REQUEST FOR CERTIFICATE OF APPROPRIATENESS

MPC File No.: 26-002724-COA

Address: 411 West 39th Street

Date: June 24, 2026

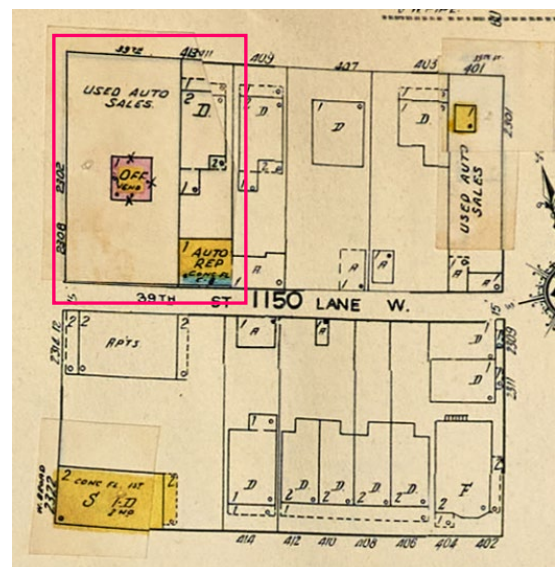
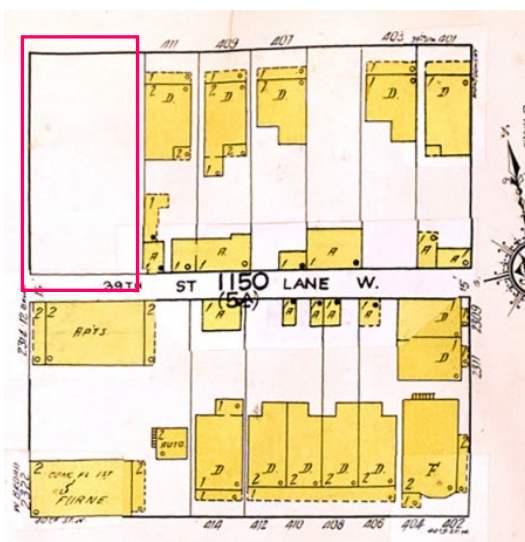
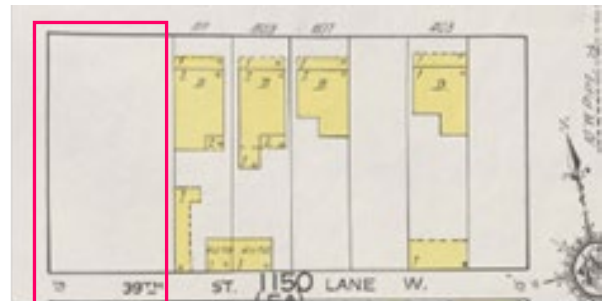
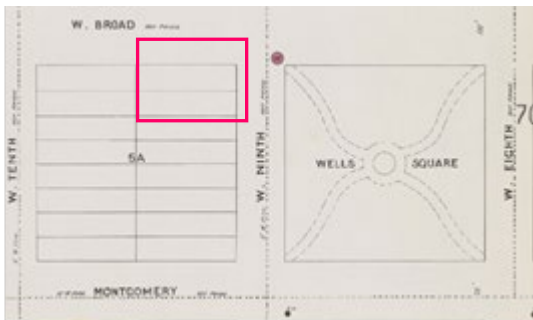
will not be taller than this two-story wood frame dwelling. The street elevation below shows the proposed streetscape with the existing contributing building at the center and still remaining a focal point of the block. Wells Park is across the street, where there are no other buildings on the opposite side of the street.
